Service Bulletin

Title: SB 412AC-2502; Bell 412 Air Conditioner Relay Panel Wiring

Date: 29 July 2015

Applicability: Bell Helicopter 412 Aircraft equipped with the Air Comm Air Conditioning System, all serial numbers. The system serial number is marked on the compressor mount.

Figure 3: Drawing showing components to be removed

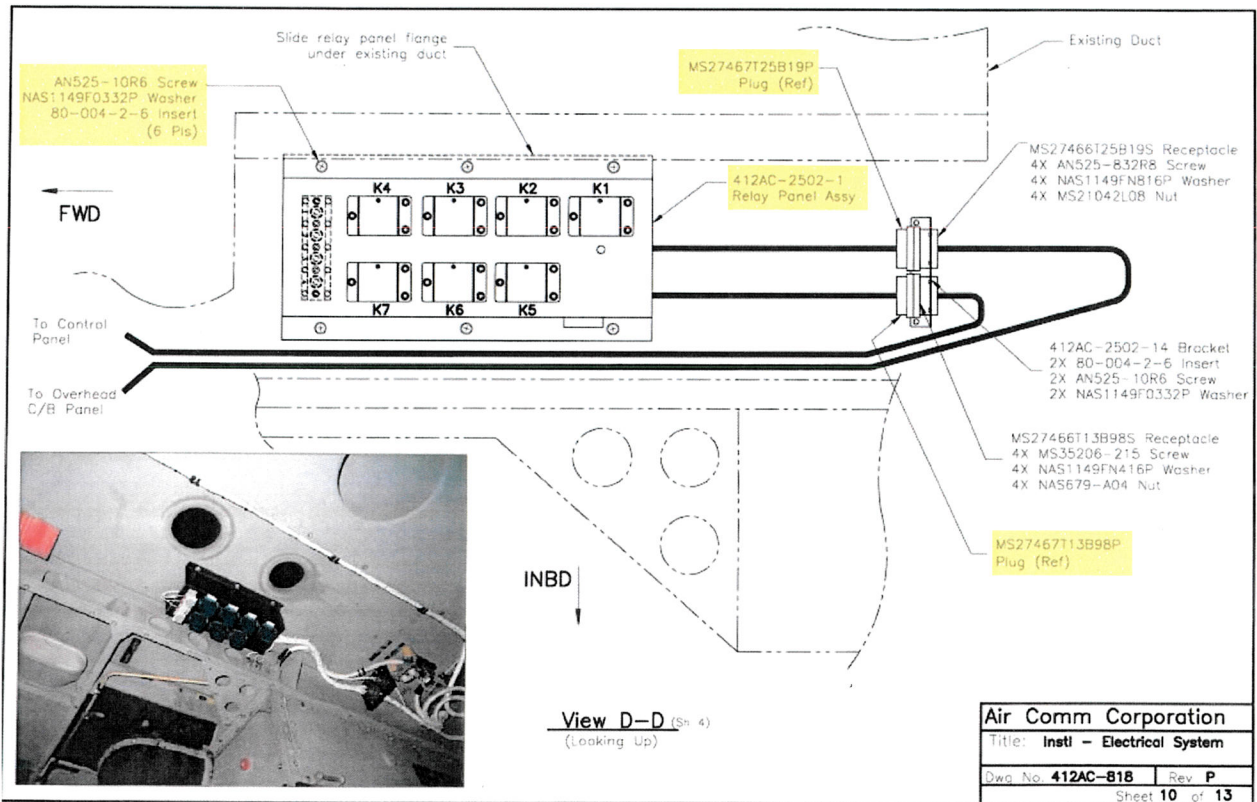
1. Ensure electrical power is removed from the non-essential bus that powers the AC system.
2. Disconnect the MS27467T25B19P and MS27467T13B98P Amphenol connectors from the bracketed receptacles aft of the relay panel.
3. Carefully remove the relay panel by removing the six (6) AN525-10R6 screws securing the relay panel to the cabin top.

Figure 3: Underside of relay panel showing components and wiring

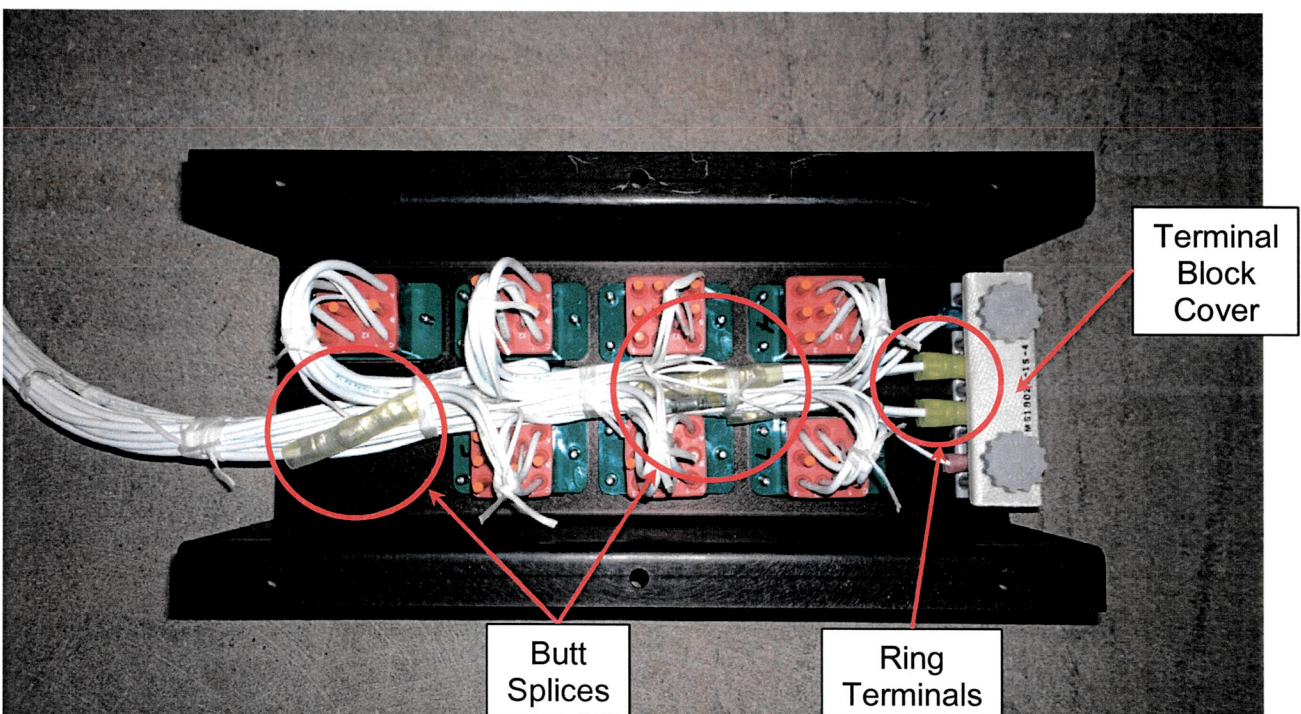
1. Turn the relay panel over to observe the wiring and components.
2. It is necessary to carefully cut away any cable ties and/or lacing tape that may be holding the wire bundle together, in order to gain access to all splices.

3. It will be necessary to remove the cover of the terminal block in order to enable the ring terminals to be fully visible.
4. Carefully inspect each butt splice and ring terminal attached to the terminal block for signs of heat-related discoloration, melted plastic or charred material.

5. Carefully inspect the wiring to ensure all insulation is intact and no brown or black heat-related discoloration is present. Check wires for signs of nicks and cuts due to chafing against other components or sheet metal.

6. If any overheated components are found, the air conditioning system must be placed in a non-operational state and remain deactivated until the panel is replaced. Flight is permitted as long as the air conditioner remains deactivated. Contact Air Comm for instructions on how to obtain a replacement unit.
